Reviewed By CED  
12/10/2021 3:24:12 PM  
By mschmitz

PROJECT:	FAMILY EYECARE CENTER	SHEET TITLE:	DATE:	PROJECT NUMBER:	SMP	LOCATION:	ADDRESS:							
Electrical - Site Photometric														
Revisions														
NO.	DESCRIPTION	PERMIT/BIDDING SET												
1	ELEC SERVICE ADDENDUM 1 - 10/5/21

ES1.01

SITE PLAN  
1/8" = 1'-0"

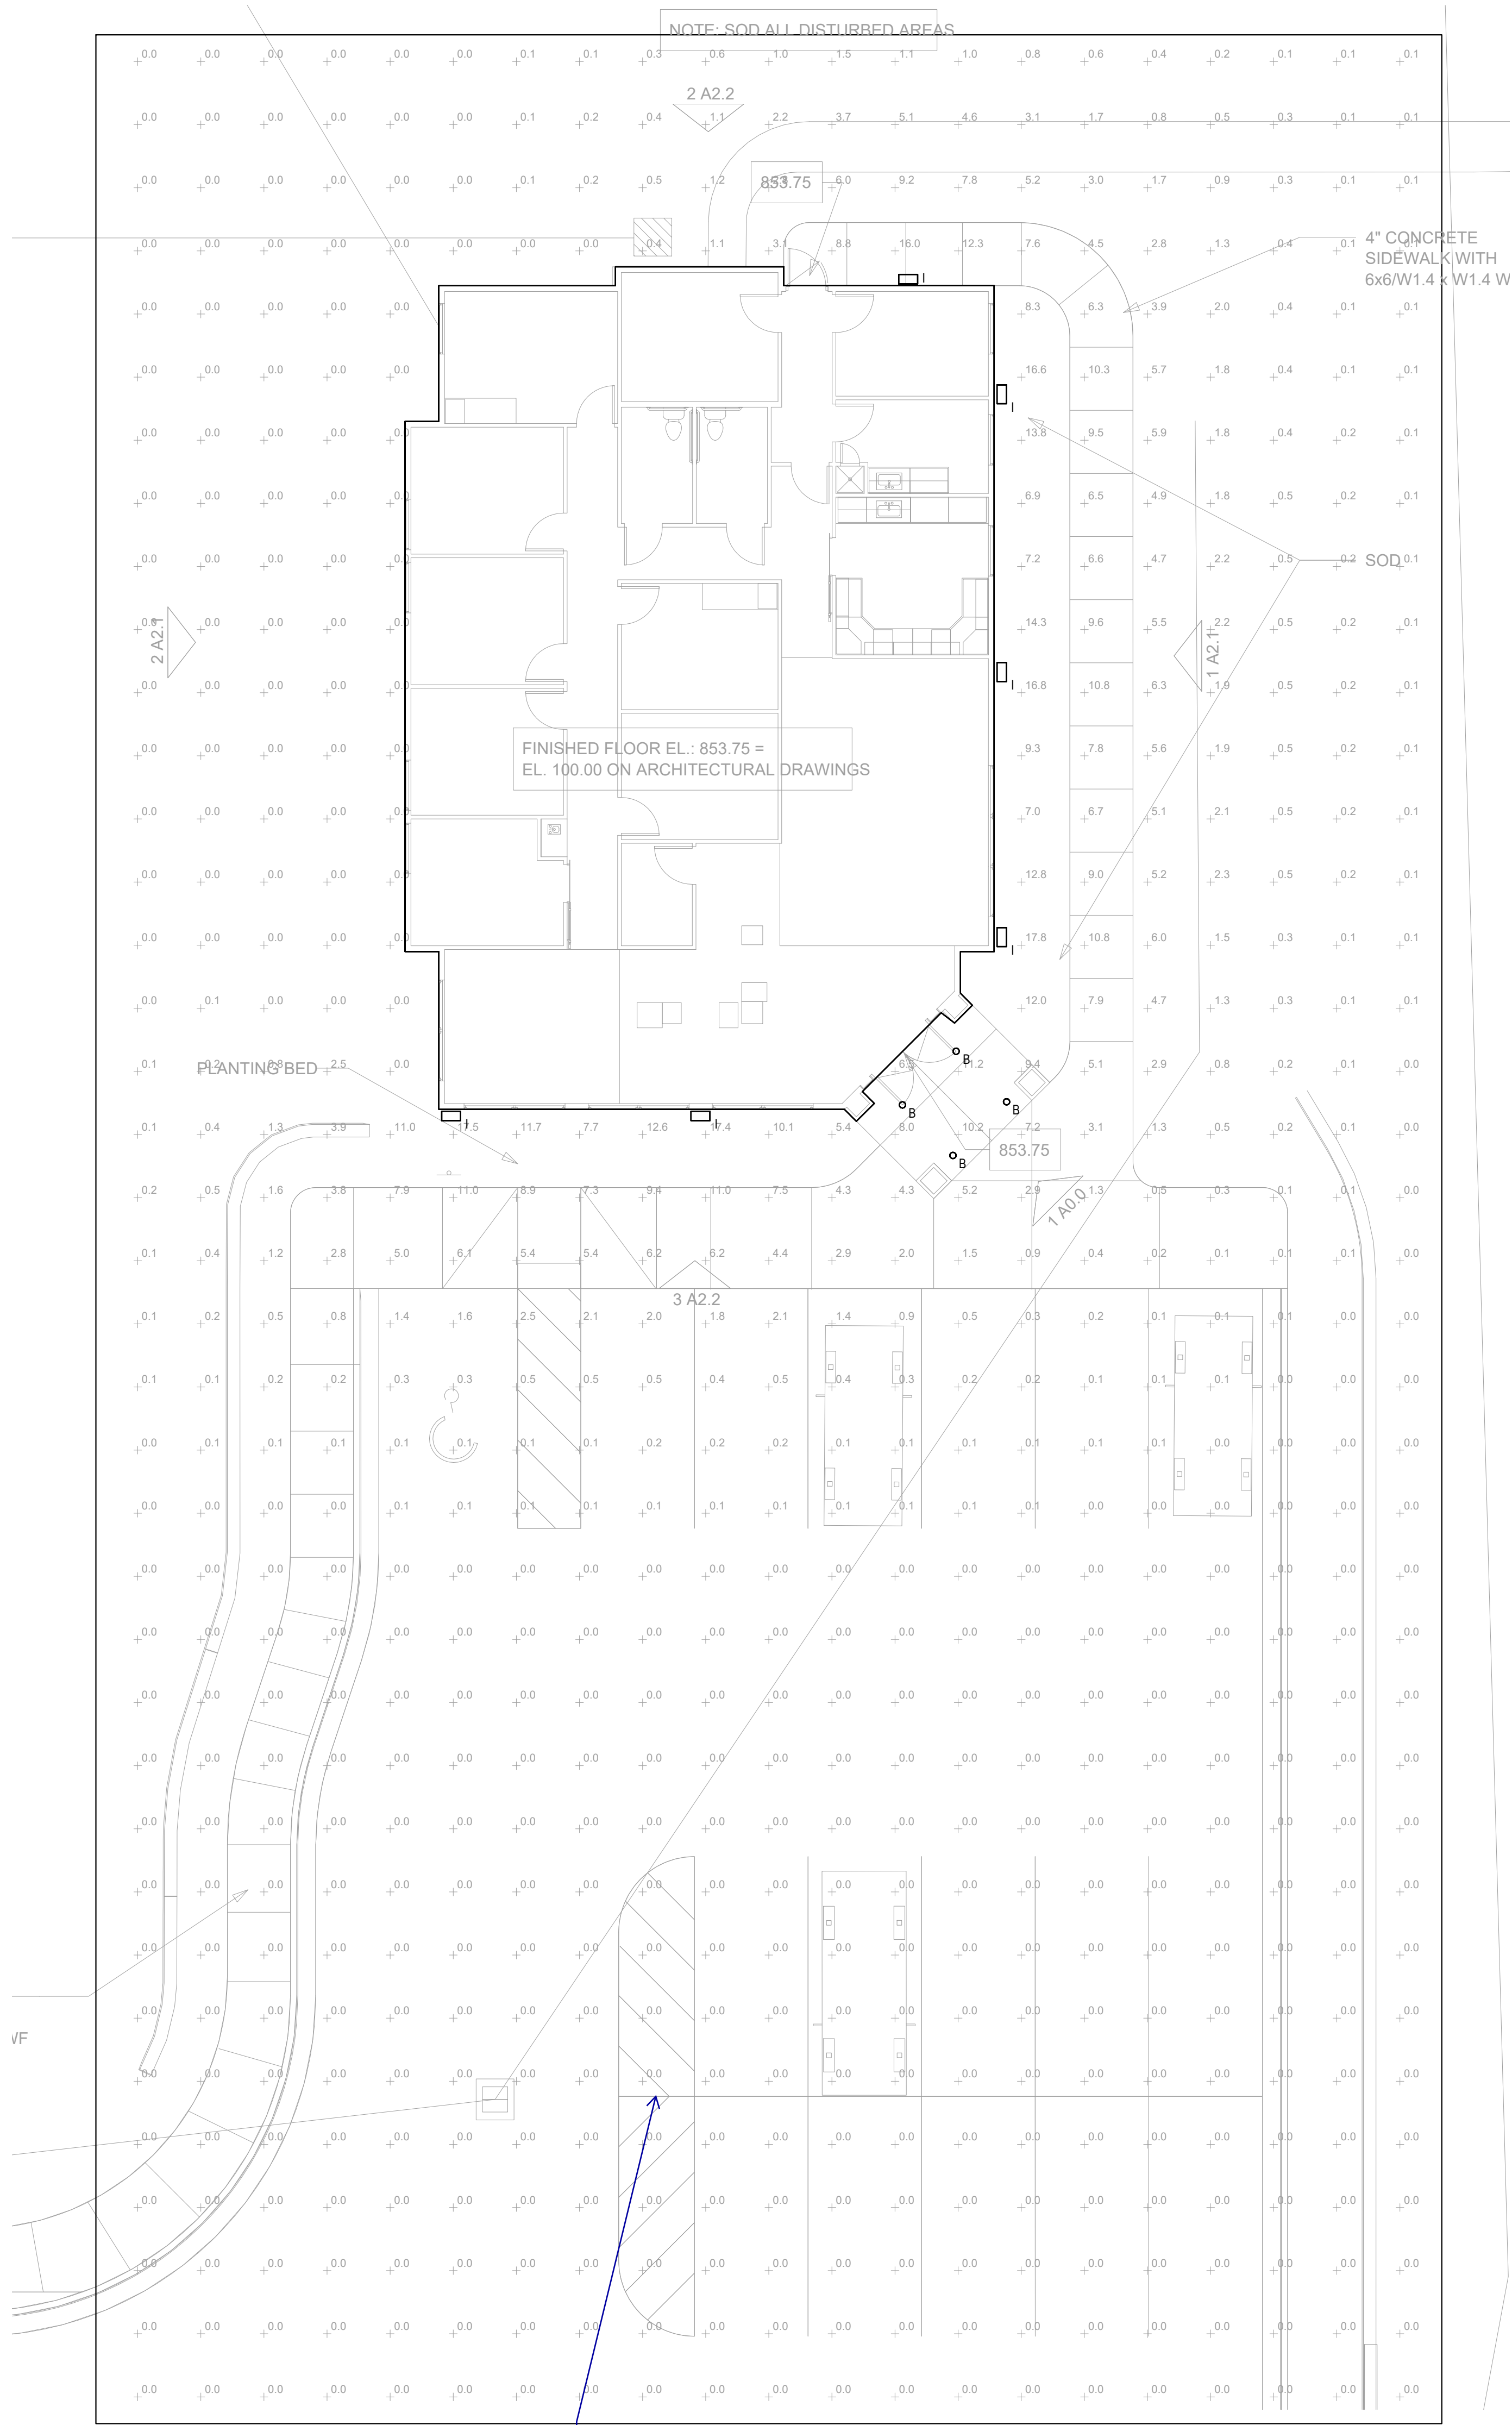
Would strongly suggest the addition of one pole light in this area with a 4-way luminaire assembly to provide lighting for the parking lot area.
